Access Compliance Report Public Rights-of-Way (Curb Ramps)

Intersection ID: 45501 Main Street: BUGGY HORSE RD **Cross Street: CAPTAIN ARDREY RD** Location: N **ADA ID: 2D9C8CC955D8** Ramp Type: PerpDiag Initial Pass/Fail: Fail **Overall Compliance: No Severity Score:** 22.5

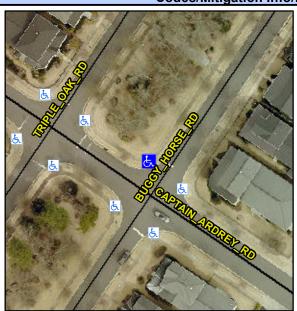
Not Found, R304.5.1, R304.2.2, R304.5.3

Compliance Description Da		Data	Compliance Description		Data
N/A	Ramp Length (in)	72.0	No	Ramp Slope (%)	9.8
No	Ramp Width (in)	38.0	No	Ramp XSlope (%)	2.5
N/A	Flare Type LT	N/A	N/A	Flare Type RT	N/A
N/A	Flare Slope LT (%)	N/A	N/A	Flare Slope RT (%)	N/A
N/A	Flare Traversable LT?	N/A	N/A	Flare Traversable RT?	N/A
N/A	Landing Length (in)	N/A	N/A	DWS Provided?	N/A
N/A	Landing Width (in)	N/A	N/A	DWS Contrast?	N/A
N/A	Landing Slope (%)	N/A	N/A	DWS Length (in)	N/A
N/A	Landing X Slope (%)	N/A	N/A	DWS Full Width?	N/A
N/A	Landing Curb? (Y/N)	N/A	N/A	DWS Offset (in)	N/A
N/A	Shared Landing?	N/A			
N/A	Gutter Ponding?	N/A	N/A	Gutter Slope (%)	N/A
N/A	Gutter Lip Ht (in)	N/A	N/A	Gutter X Slope (%)	N/A
N/A	Painted X Walk1?	No	N/A	Painted X Walk2?	No
	X Walk 1 Direction	To SW		X Walk 2 Direction	To SE
N/A	X Walk 1 Width (in)	N/A	N/A	X Walk 2 Width (in)	N/A
	X Walk 1 Slope (%)	1.6		X Walk 2 Slope (%)	3.1
	X Walk 1 X Slope (%)	4.0		X Walk 2 X Slope (%)	0.5

Street 1 Name Stop Condition-Street 2 Street 2 Name Stop Condition-Street 1 **CAPTAIN ARDREY RD** None **BUGGY HORSE RD** StopSign Remove & Replace Curb Ramp With Two New Directional Ramps or Equivalent.
